**REMARKS**

This Amendment is a full and timely response to the Office Action dated March 19, 2004. A Petition to Extend the Time for this Response to Within the Third Extended Month accompanies this submission. Reexamination and reconsideration are respectfully requested.

Fig.5

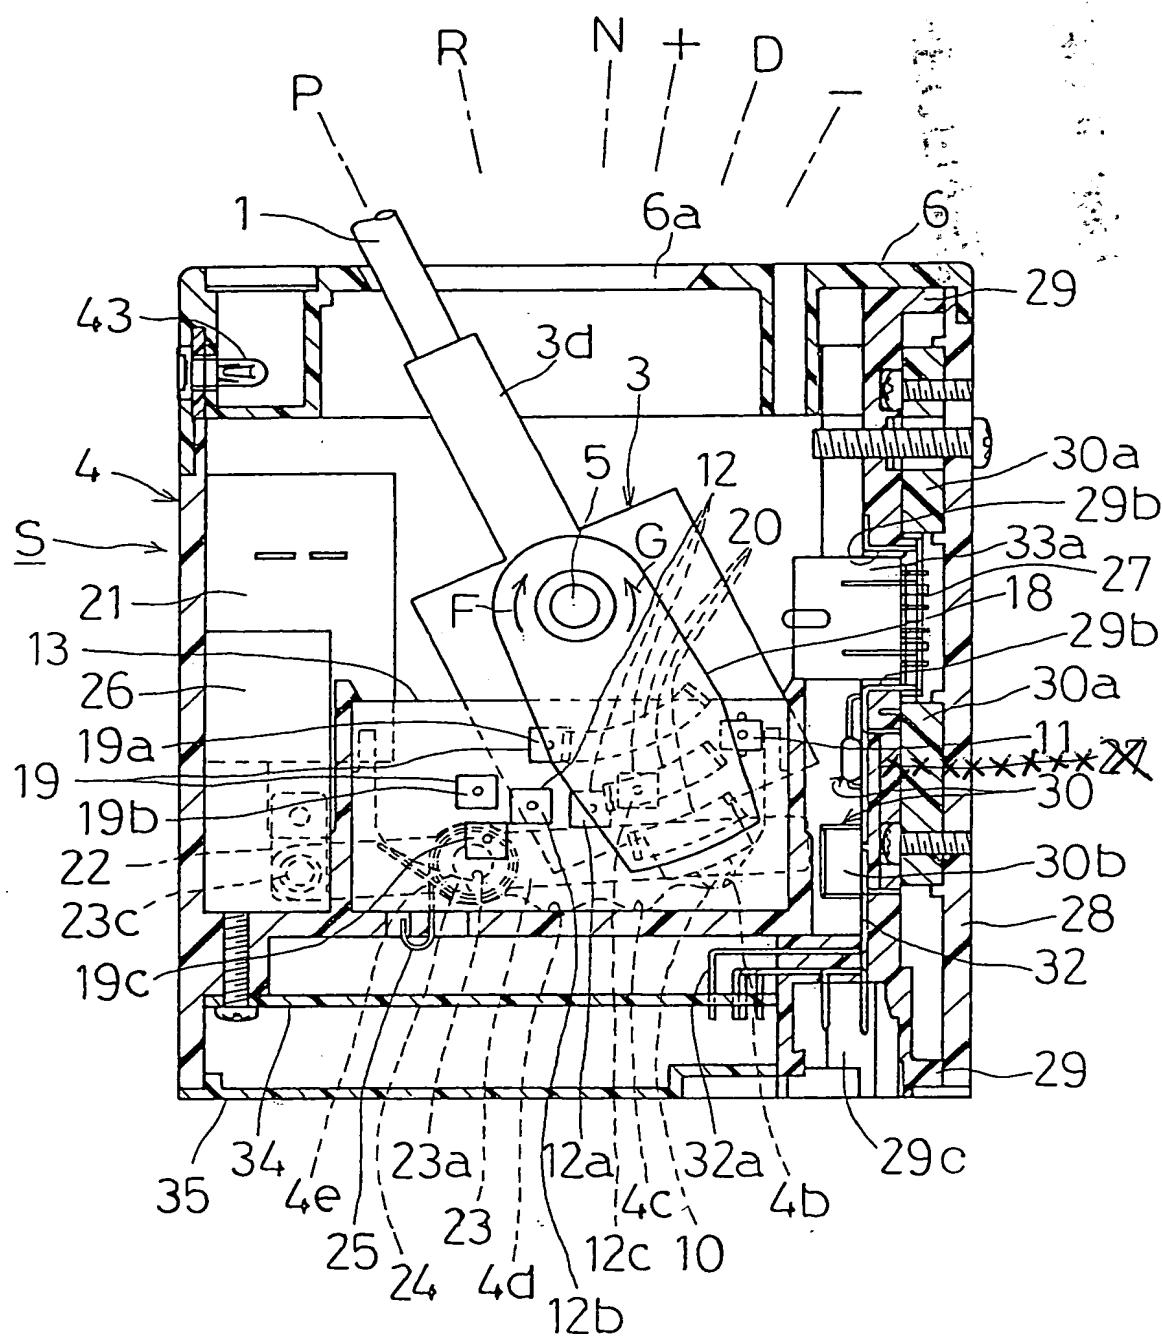
Changes are made to the drawings to conform with the specification, and/or to address requirements for correction as suggested by the examiner.. Specifically, a numeral 3a is added to Fig. 5 to define the opening for the member 7 to overcome the objection in Section 3 of the Action.. The text is modified at page 14 to mention surface 3i to overcome the object stted in Section 4 on page 3 of the Action.. The lower number 27 in Fig. 4 is deleted to overcome the objection in Section 5 of the Page 3 of the Action. As to the objection noted in Fig. 6, the groove 4a appears to be shown in Fig. 5 on which the ball 10 biased by the spring 9 in the opening 3g rides.
